U.S. Appln No. 09/976,925
Page 9

REMARKS/ARGUMENTS

ANNOTATED COPY

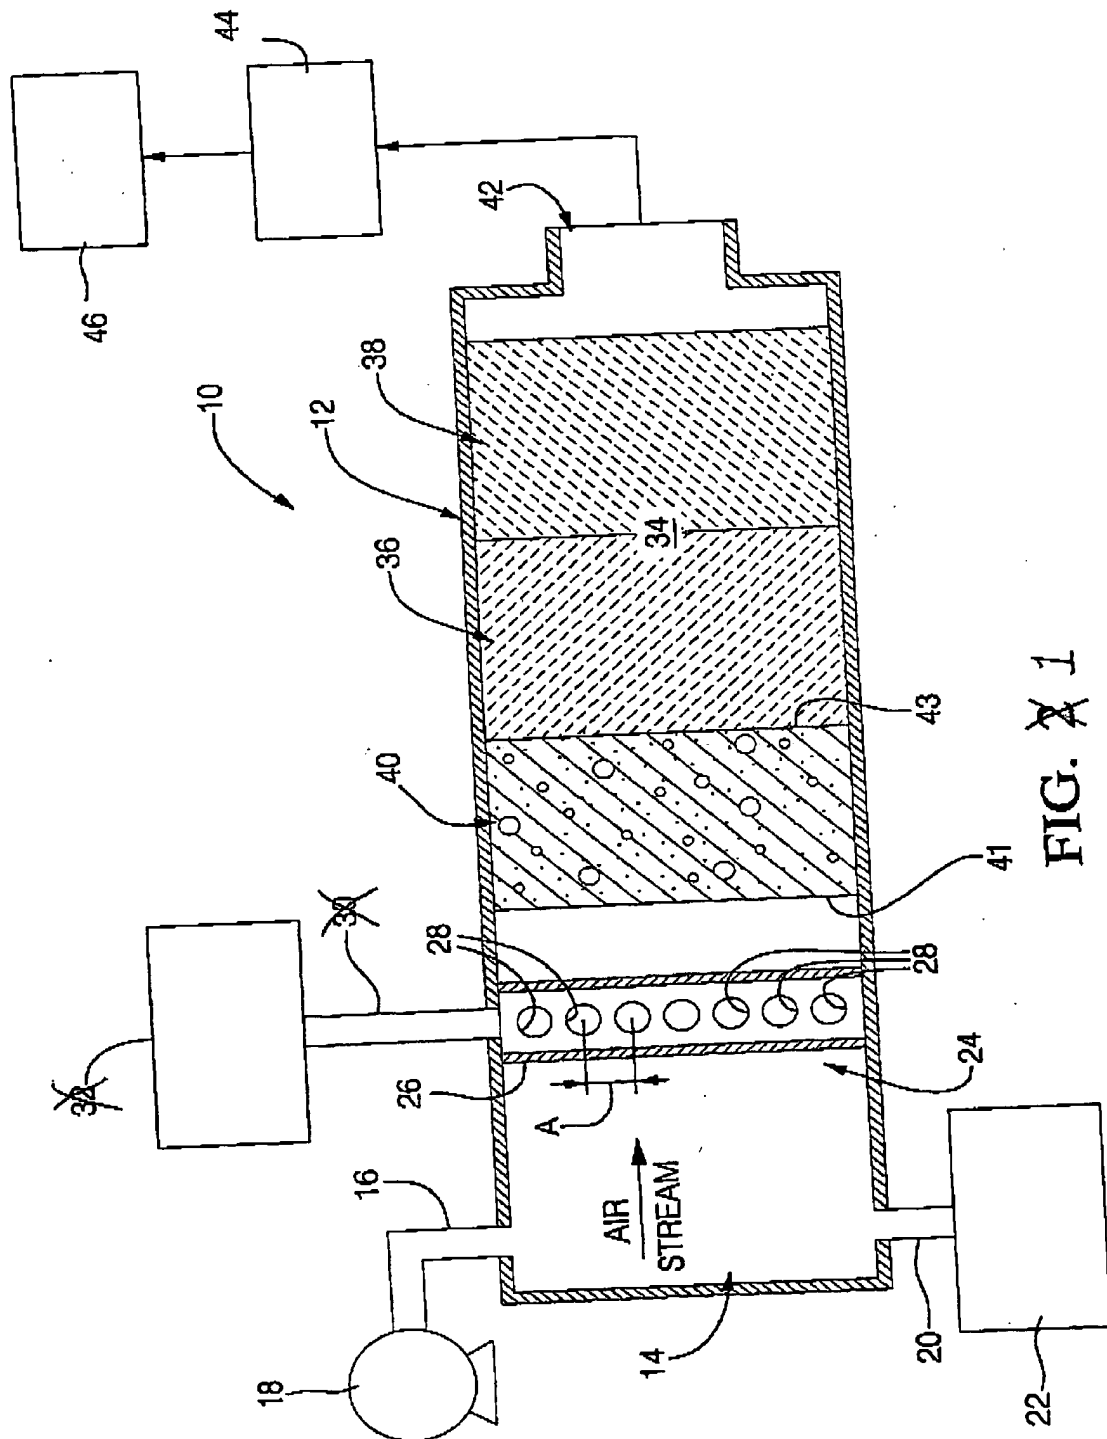
The drawings had been objected to as failing to comply with 37 CFR 1.84(p)(5) because they include the reference numerals "30" and "32" in both Figures 1 and 2. Applicants have amended Figures 1 and 2 to remove numerals 30 and 32. Withdrawal of the rejection is respectfully requested.

Applicants have also amended the drawings such that sheet 1/2 has changed "FIG. 2" to "FIG. 1".
